**NOTICE OF ADDENDUM
ADDENDUM NO. 4
City of Madison, Engineering Department**

**CONTRACT NO. 7769
SYCAMORE AVE. PUBLIC WORKS MAINTENANCE FACILITY-OFFICE REMODEL PROJECT**

This addendum is issued to modify, explain or correct the original Drawings, Specifications, or Contract Documents marked as **Sycamore Ave. Public Works Maintenance Facility – Office Remodel Project, City of Madison, Contract #7769, as issued on May 15, 2019** and is hereby made a part of the contract documents.

1 FIRST FLOOR OFFICE DEMO PLAN
SCALE: 1/8" = 1'-0"

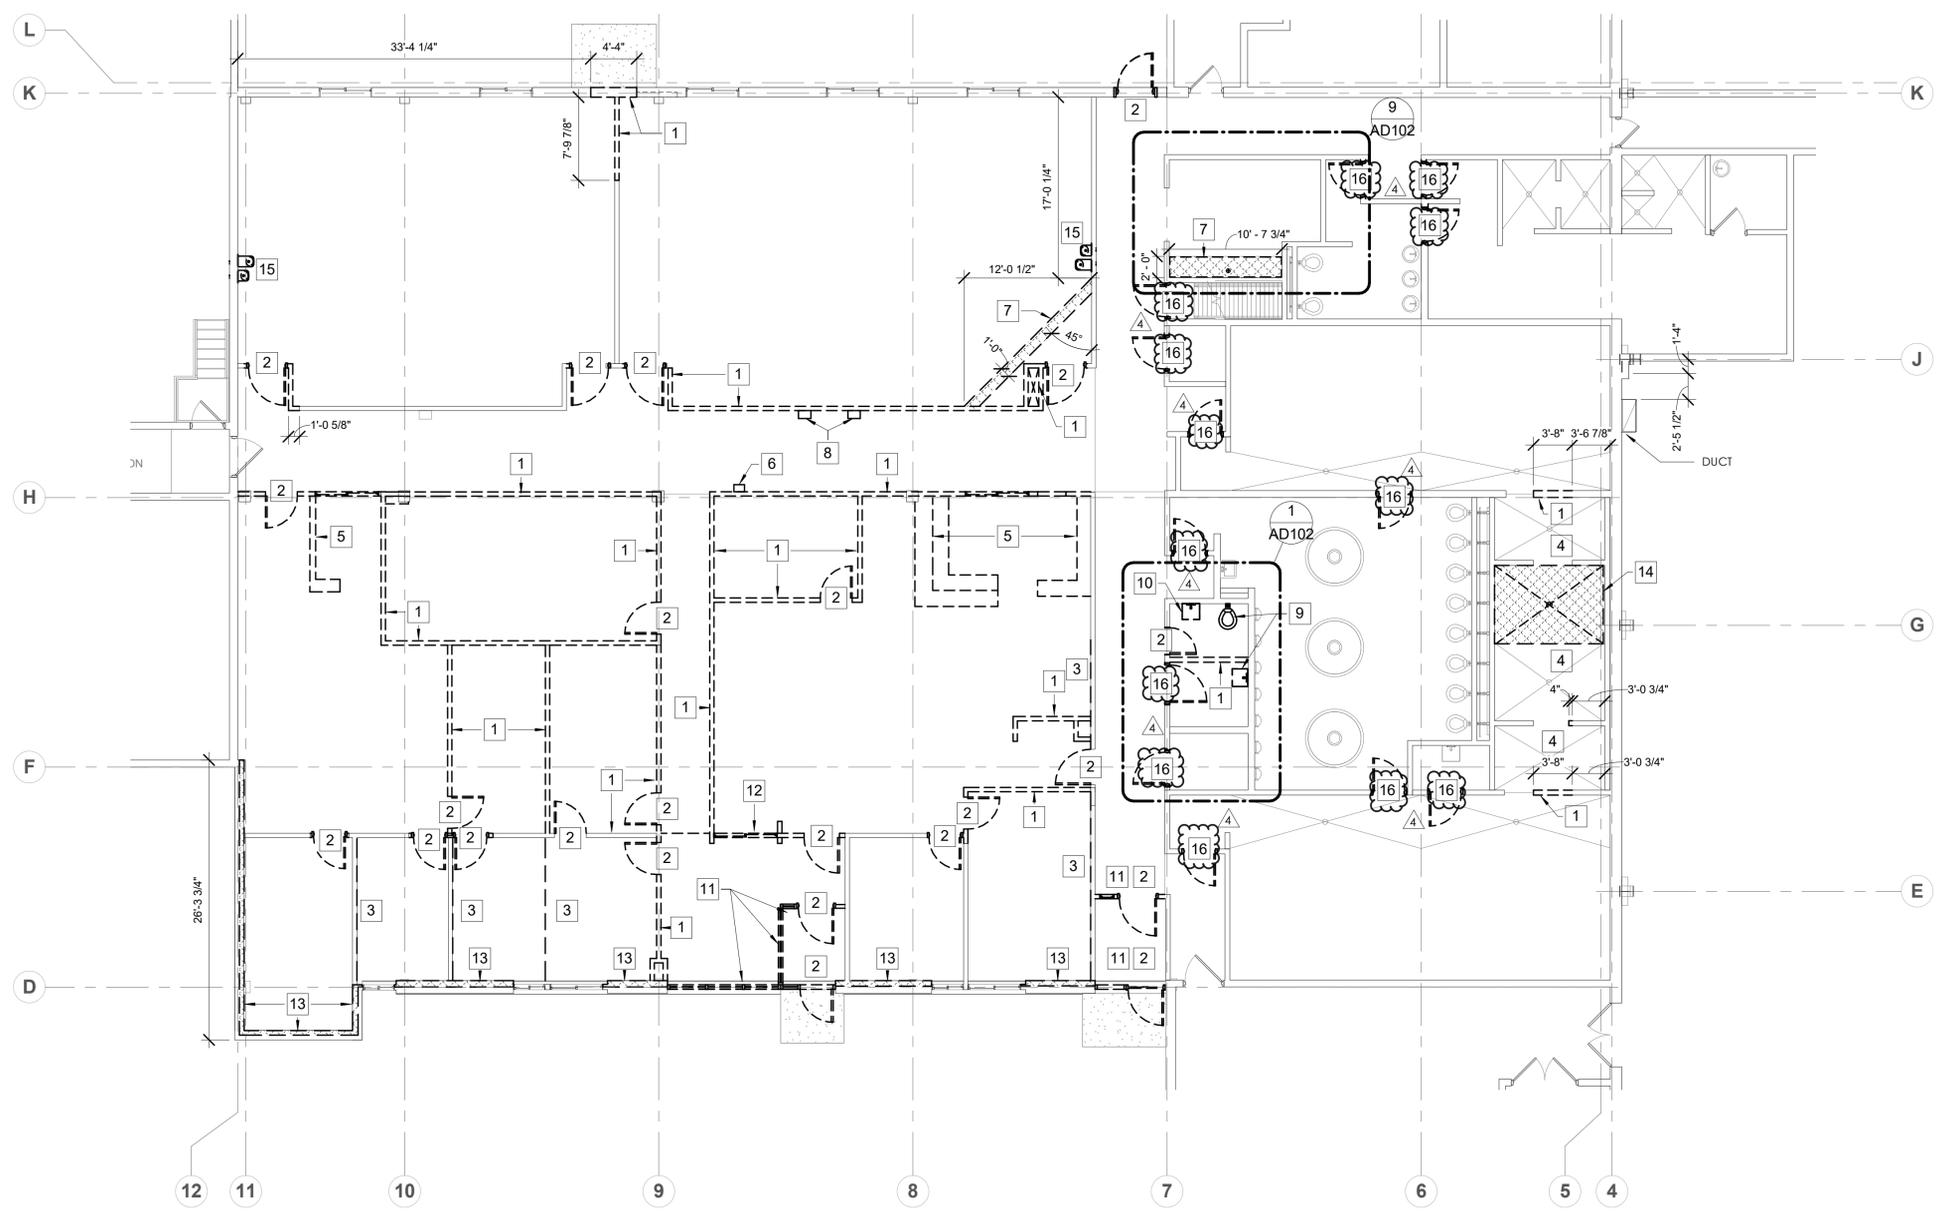
1. **GENERAL CONTRACT CONDITIONS**
 - A. No Change.
2. **GENERAL QUESTIONS AND ANSWERS**
 - A. No Change.
3. **ACCEPTABLE EQUIVALENTS**
 - A. No Change.
4. **SPECIFICATIONS**
 - A. No Change.
5. **DRAWINGS**
 - A. Architectural
 - i. **Drawing AD101: (Remove and replace with attached sheet):** Added Keynote #16 to the keynote legend and to the plan.
 - ii. **Drawing A700: (Remove and replace with attached sheet):** Updated Door Schedule.
6. **PROPOSAL SPECIFICATIONS**
 - A. No Change.
